Proposals

Of the Russian Federation in regards to the ECE Regulations No. 111 Concerning the Approval of Tank Vehicles of Categories N and O with Regard to Rollover Stability

Transmitted by the Russian Federation

The scheme of "Tilt test"

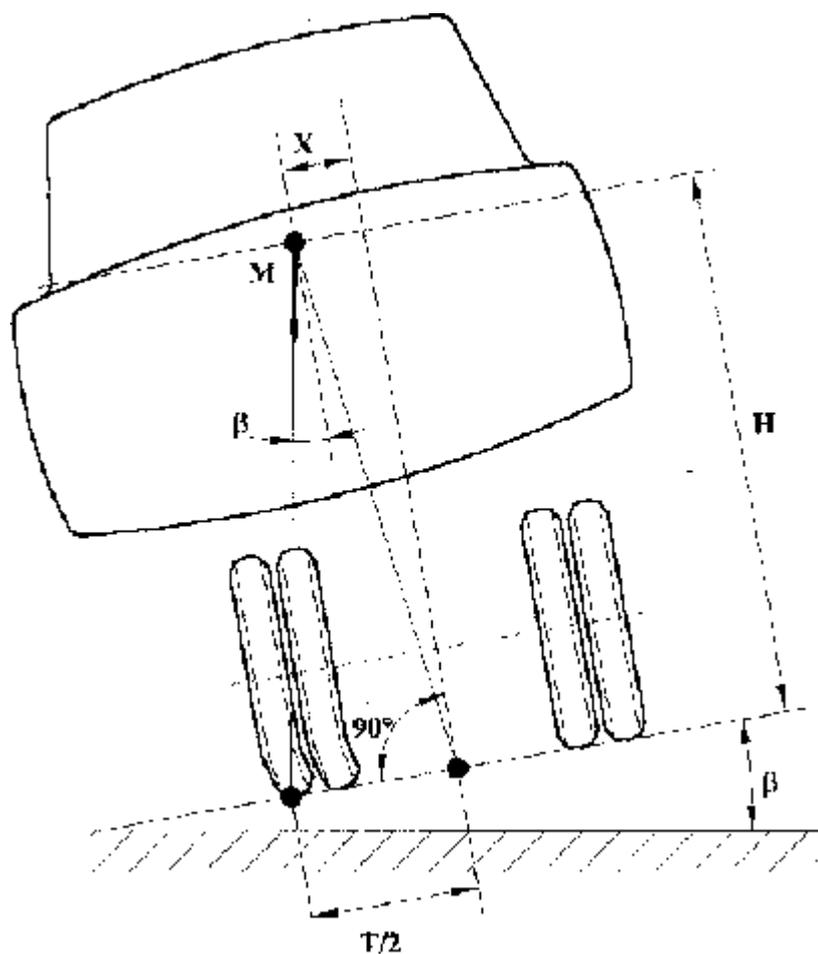
1. The first proposal concerns Annex 3, p. 5 - vehicle loading

The test procedure is as follows. It is suggested to load the tank by water. If the normal fluid for carriage is petrol (or other fluid lighter than water), the tank is loaded partly (in case of petrol -75% of the volume). When tilting the platform, the fluid center-of-gravity deviates to the direction of tilting. If the vehicle rolls over at the platform inclination angle $P < 23^\circ$, (3 shall be corrected because deviation of the fluid center-of-gravity deteriorates this criterion.

In accordance with the p. 5, the manufacturer shall submit calculation of the correction coefficient.

The calculation of the correction coefficient is more complicated than calculation described in the Annex 5 of the Regulations, which, in accordance with the p. 5.1.2 of the Regulations, in case of doubts (perhaps, when (3 is close to 23°), should be checked by the test on a tilting platform. Thus test results are verified by the similar tests, which is not acceptable.,

The tank vehicle should be loaded fully by water. Overloading by 30% should not cause vehicle malfunctioning or touching the jounce limiters by the suspension springs. In this case the fluid center of gravity will not deviate from the vehicle centerline and the correction formula for a tank vehicle of any shape can be written as follows:

$$\operatorname{tg}\beta_g = \operatorname{tg}\beta_w \frac{M_g}{M_w} \frac{H_w}{H_g} + \frac{T}{2H_g} \left(1 - \frac{M_g}{M_w} \right)$$

The correction according to the mentioned formula shall be performed only in case when ($\beta < 23^\circ$ (limit)), as loading a tank by water instead of lighter fluid increases the value of β .

When tilting the platform during static stability testing (please refer to the figure),

$$\begin{aligned} \operatorname{tg}\beta_w &= \left(\frac{T}{2} - X_w\right) / H_w; \text{ so } X_w = -\operatorname{tg}\beta_w \cdot H_w + \frac{T}{2} \\ \operatorname{tg}\beta_g &= \left(\frac{T}{2} - X_g\right) / H_g \end{aligned}$$

$$\operatorname{tg}\beta_g = \operatorname{tg}\beta_w \cdot \frac{H_w}{H_g} \cdot \frac{M_g}{M_w} + \frac{T}{2H_g} \left(1 - \frac{M_g}{M_w}\right)$$
